4.2.1 GRED Drilling Award – GRED III Phase II

Presentation Number: 011

Investigator: Karl, Bernie (Chena Hot Springs Resort)

Figure 11: GRED Drilling Award – GRED III Phase II

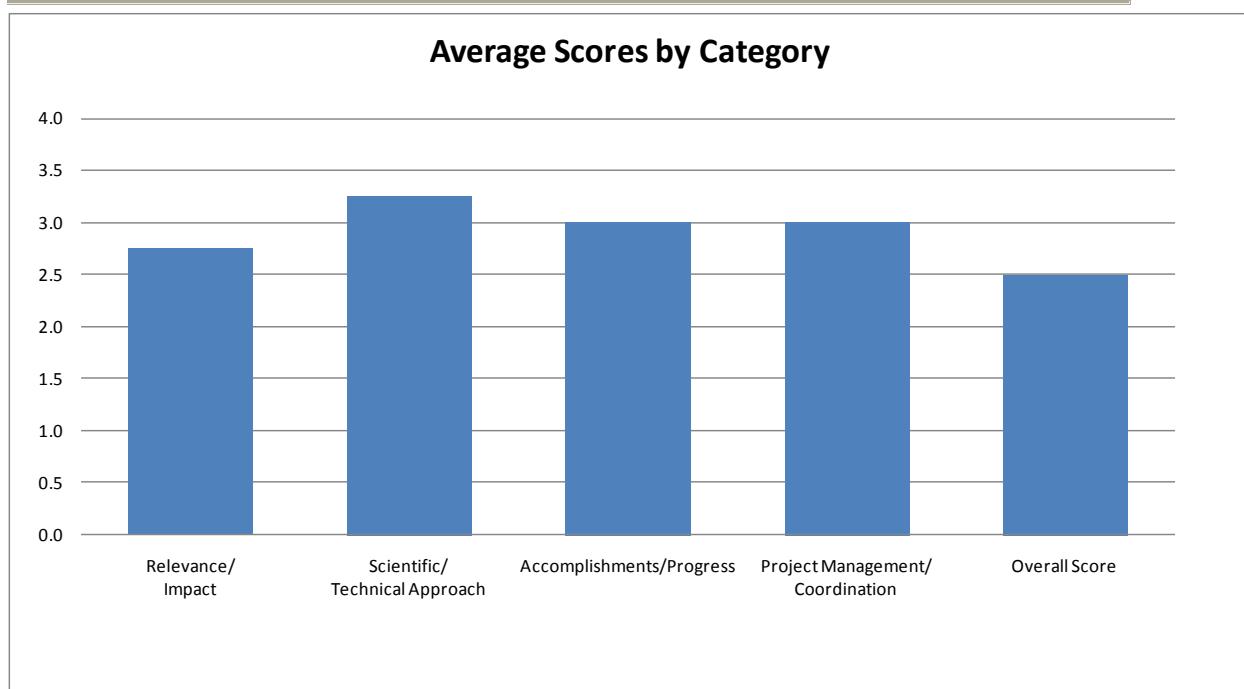
Average Overall Score: 2.5/4.0
